**Invensys Response to
Request for Additional Information (RAI)**
Ref: Letter dated December 8, 2010, NRC to Invensys

<u>Attachment</u>	<u>RAI No.</u>	<u>Description</u>
1	1	RXM Safety/Non-safety Interface versus Interim Staff Guidance (ISG)-4
2	2	Assignment of Safety-related and Non-safety I/O to RXM Chassis
3	3	Testing Related to RXM Chassis Failures
4	4	Document Listing for FPGA Development
5	5	Response Time Compliance with EPRI 107330
6	6	Determinism and Use of Interrupts

Main Processor

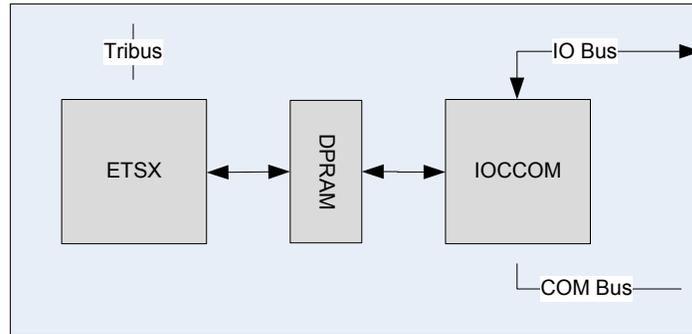
In Section 2.1.3.3 of the Triconex Topical Report Revision 3, Invensys document 7286-545-1, Invensys states that the TriStation 1131 function subset does not allow constructs that could lead to non-deterministic timing. However, there is no mention of the deterministic behavior of the Tricon design itself. Please provide a description of the deterministic behavior of the Tricon platform, including interrupt handling.

The 3008N Main Processor module consists of three main subsystems as shown in the figure below:

Each subsystem consists of a microprocessor and memory subsystem. The ETSX (Enhanced Triconex System Executive) is responsible for running the user defined application program on the Application Processor. The IOCCOM Processor is responsible for communications with the I/O modules in the system and the Tricon communications modules (TCM). The DPRAM provides the interface between the ETSX and IOCCOM. The DPRAM is divided into several sections:
